# SERVICE BULLETIN

M-968

SEPTEMBER 2, 1988

## 1340 cc ONE PIECE FLYWHEEL-PINION SHAFT

Figure 1. Pulling Pinion Gear

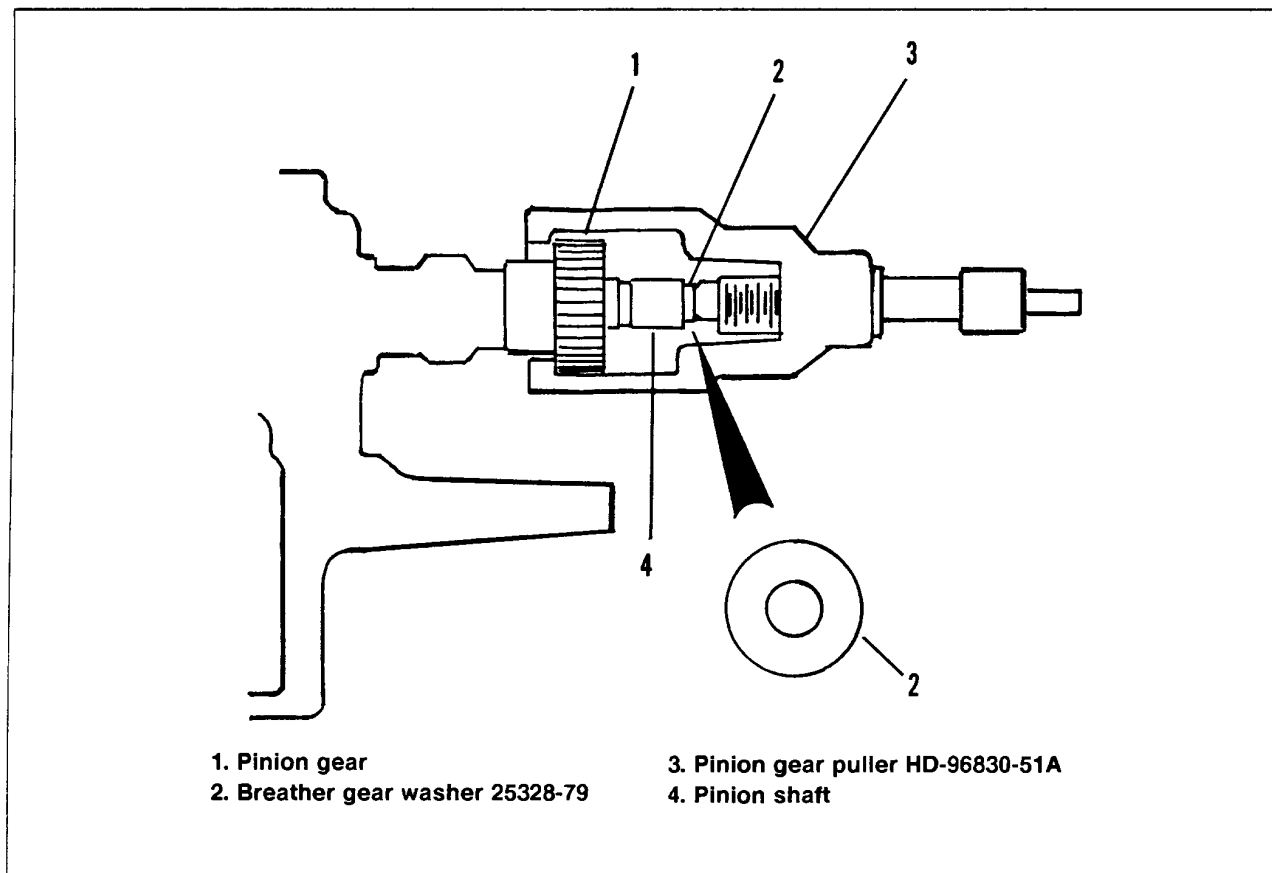
Starting with crankcase No. 1589 221 007 (49-State) and 2089 221 001 (California) all 1989 1340 production engines will be equipped with the pinion shaft and right flywheel cast as one piece. Full details as to how the new one piece flywheel half will effect maintenance and repair procedures will follow in a later Bulletin.

See Figure 1. Our immediate concern is any pulling operation which involves pressing against the end of the pinion shaft. An example is the removal of pinion gear (1). Due to the angle of the internal chamfer at the end of pinion shaft (4) there is concern that if the chamfered end of the spindle of tool (3), Part No. HD-96830-51A, were to be turned directly into the internal chamfer of pinion shaft (4) the end of the shaft may become slightly flared.

This slight distortion could prevent the shaft from fitting into the bearing of the gear cover.

To prevent any damage to the pinion shaft during removal, washer (2) Part No's 25320-79 thru 25328-79 must be positioned between the spindle of tool (3) and the end of pinion shaft (4). This washer is the steel breather gear washer used on vehicles 1979 to 1982. The breather gear washers came in various thicknesses, however, the thinner washers are preferable. The washer prevents the chamfered end of the spindle from entering the internal chamfer at the end of pinion shaft (4) eliminating any possibility of damage.

Any flywheels damaged by improper gear removal would not be covered under warranty.
